**TOWN OF HENRIETTA  
CONSERVATION BOARD MINUTES  
June 3, 2014**

**Application No. 14-009 Fastrac Markets** – For review of final site plan approval of a 6,100 square foot convenience store with drive-thru and eight dispenser gas station on an existing 8.191 acres of land located at 1820 Hylan Drive in a Planned Commercial Development District. Tax Account 161.20-1-5.12.

**Enterprise Car Sales** – For review of final site plan approval of the construction of a 3,997 square foot building and parking lot for auto sales on a 3.56 acre parcel located at 4161 West Henrietta Road in a Commercial B-1 Zoned District. Tax Account No. 175.07-1-3.

## SITE PLAN

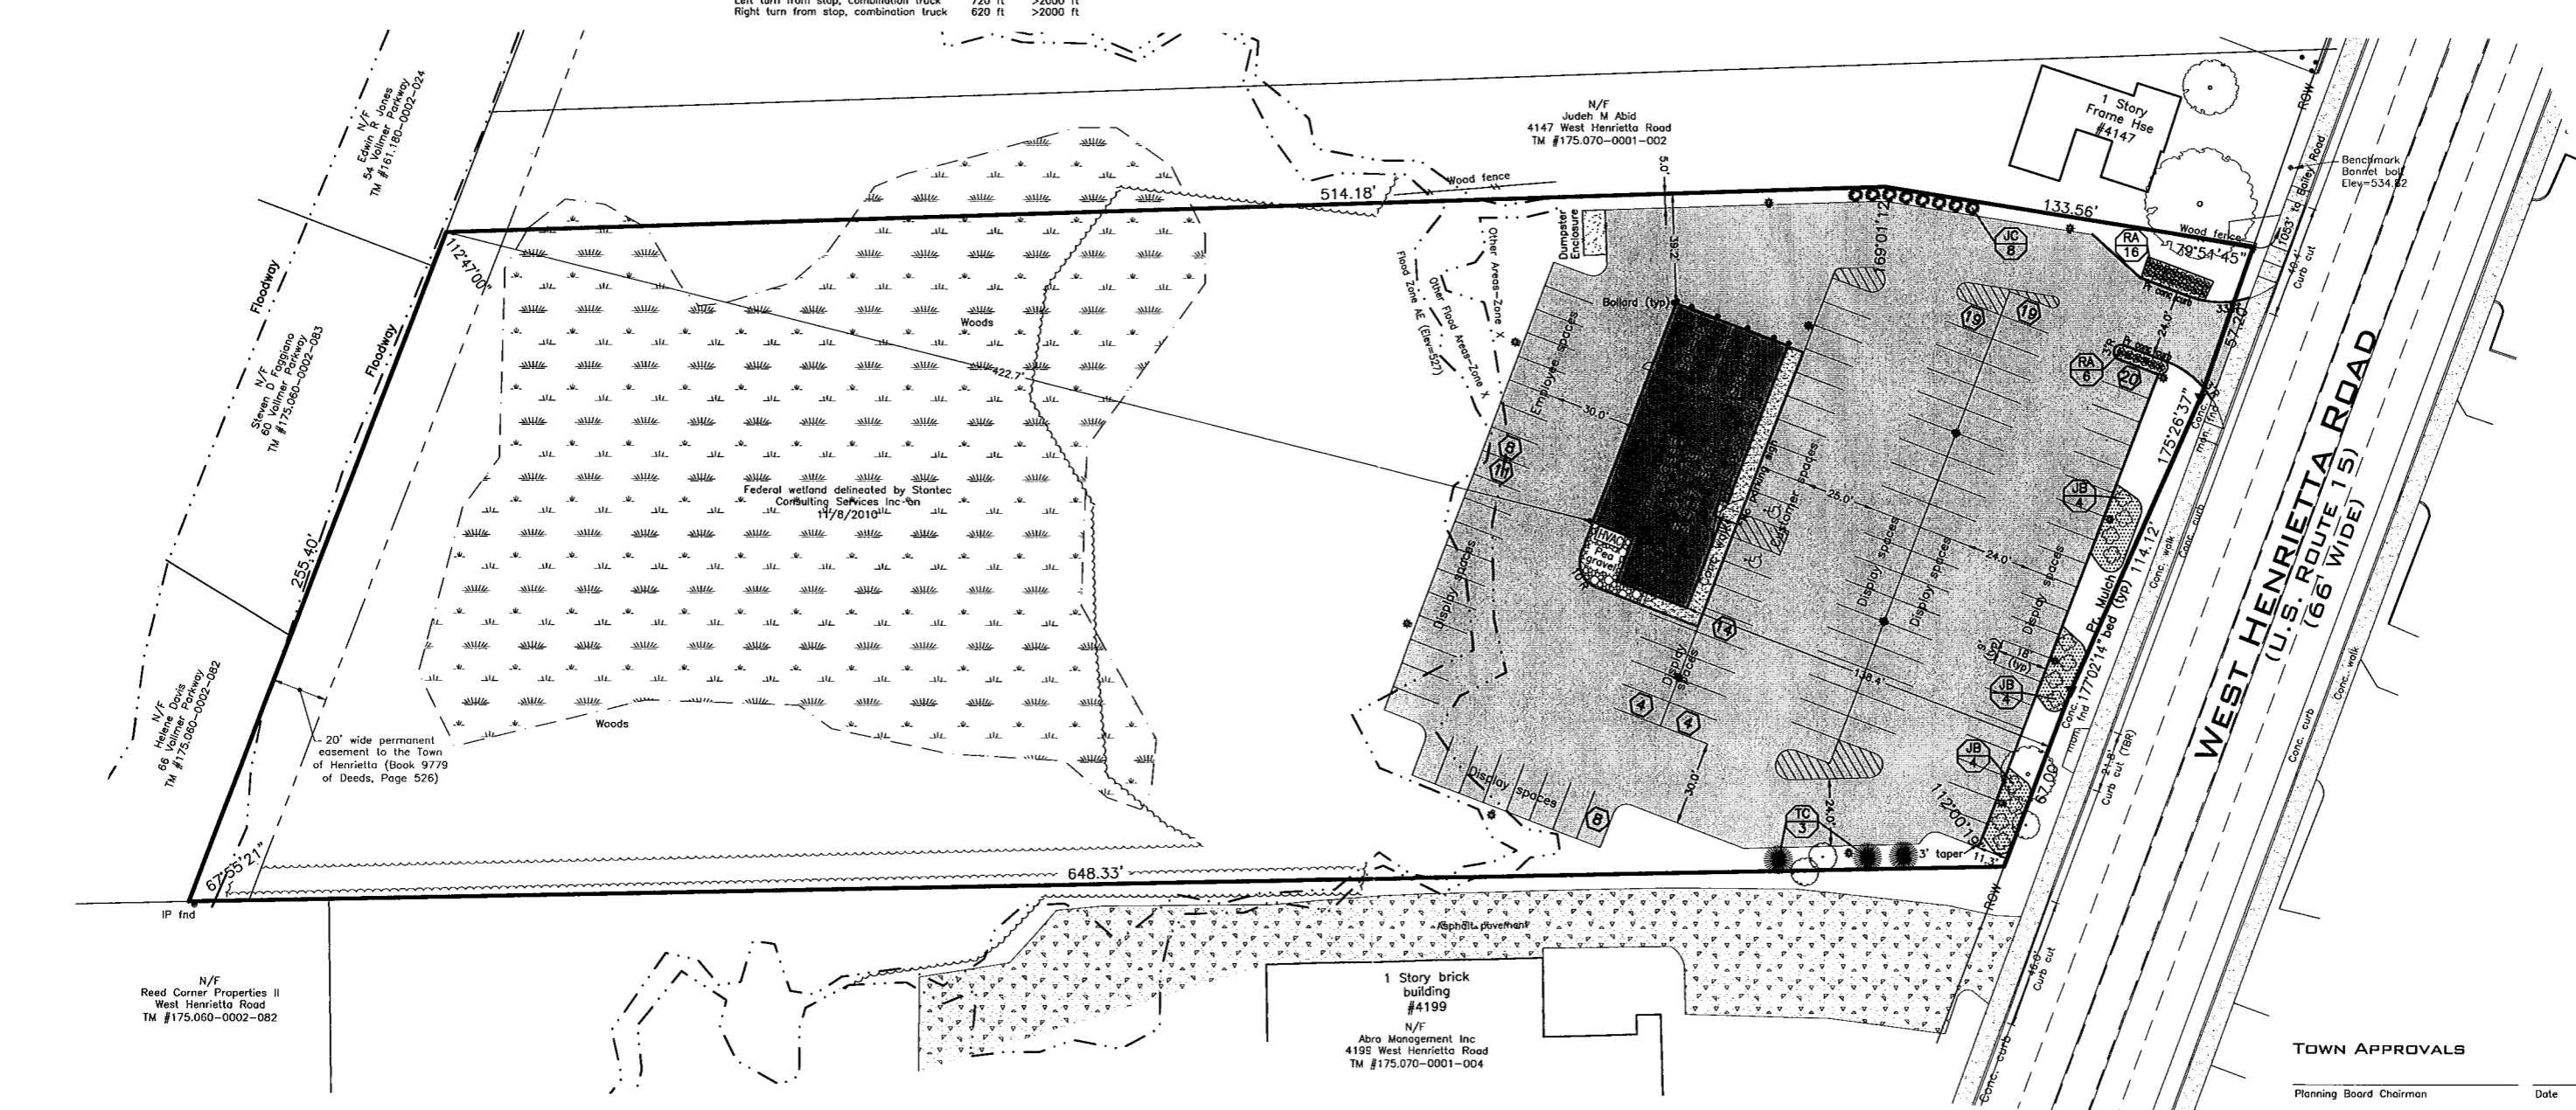
1. The proposal is not satisfying the twenty foot (20') landscape mall requirement along the front perimeter. The applicant wants the Town to consider including the area to the sidewalk into the mall measurement in order to meet the requirement.

2. The Henrietta Conservation Board is concerned with stormwater rates affecting neighbors and it helps that this Application is proposing to reduce the storm water flow rate.
